**Contains comments from the drafting task force – April 16, 2009****GLOBAL REGISTRY**

AddendumGlobal technical regulation No. xx

HYDROGEN POWERED VEHICLE  
(Established in the Global Registry on [DATE] )

Figure 1. An example of a High Level Schematic of Compressed Hydrogen Fuel Cell Vehicle

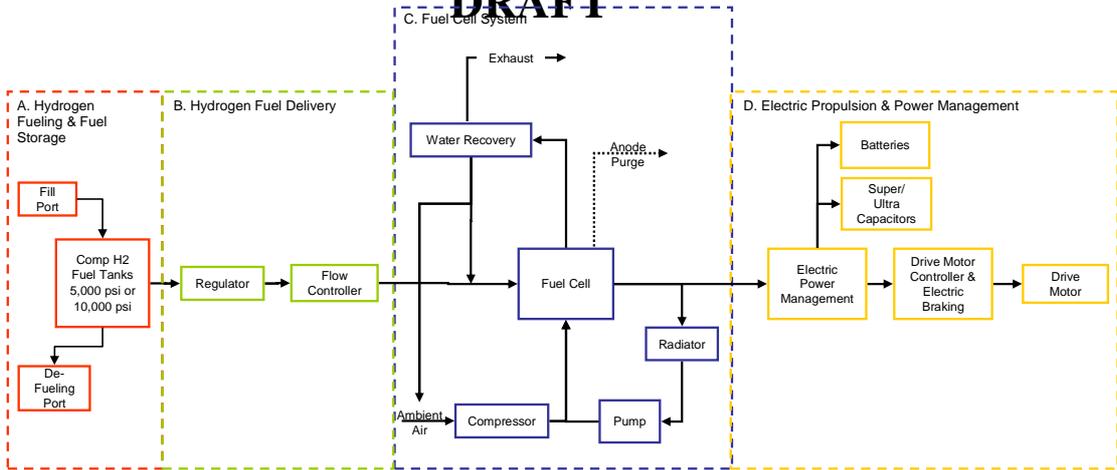
Subsystems (Glenn will provide another simpler schematic)
